SERVICE LETTER

HC-SL-61-376

Tool Modification and Alternate Propeller Mounting Hardware

Modified Torque Wrench Adapter Figure 1

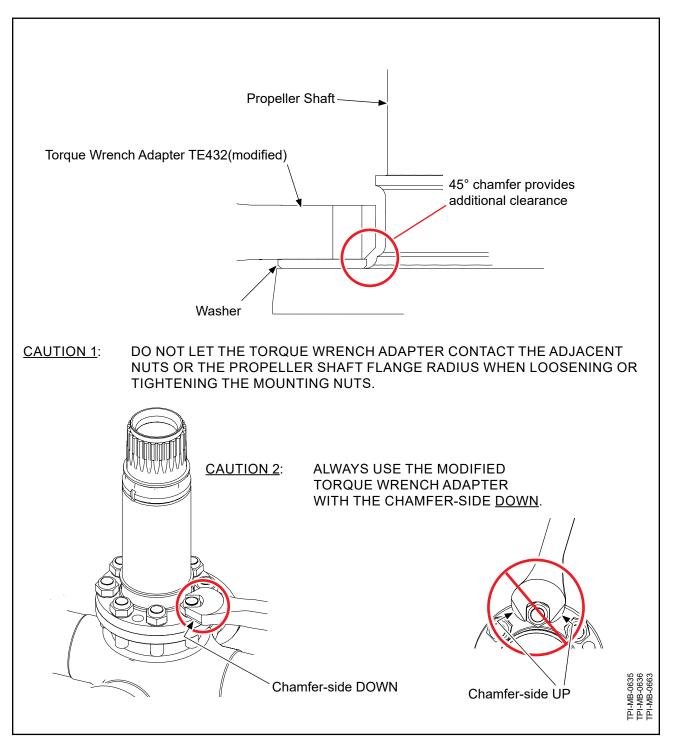
- (1) This Service Letter provides Additional Maintenance Information (AMI).
- (2) This Service Letter provides instructions for a modification of the torque wrench adapter TE432 that reduces the dimensional profile of the tool.
 - (a) The modified torque wrench adapter TE432 provides more clearance to reduce the risk of damage to the propeller shaft flange radius when installing/removing affected propellers. Refer to Figure 1.
- (3) This Service Letter introduces washer (p/n: 109514) as an alternate for washer (p/n: B-7624) used on the affected propellers.
 - (a) The washer (p/n: 109514) is a thicker than washer (p/n: B-7624). The thicker washer provides additional clearance for the torque wrench adapter TE432.

Torque Wrench Adapter Modification: Step 1 Figure 2

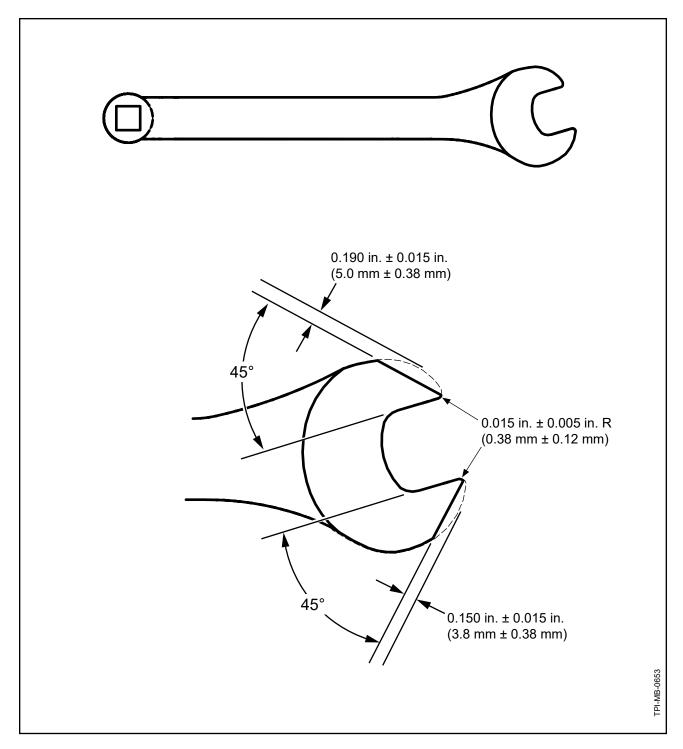
- A. Modification Instructions of Torque Wrench Adapter TE432
 - (1) Machine the head of the torque wrench adapter TE432 in accordance with the specifications shown in Figure 2 of this Service Letter.
 - (2) Machine 45° chamfers on the bottom sides of the torque wrench adapter TE432 in accordance with the specifications shown in Figure 3 of this Service Letter.
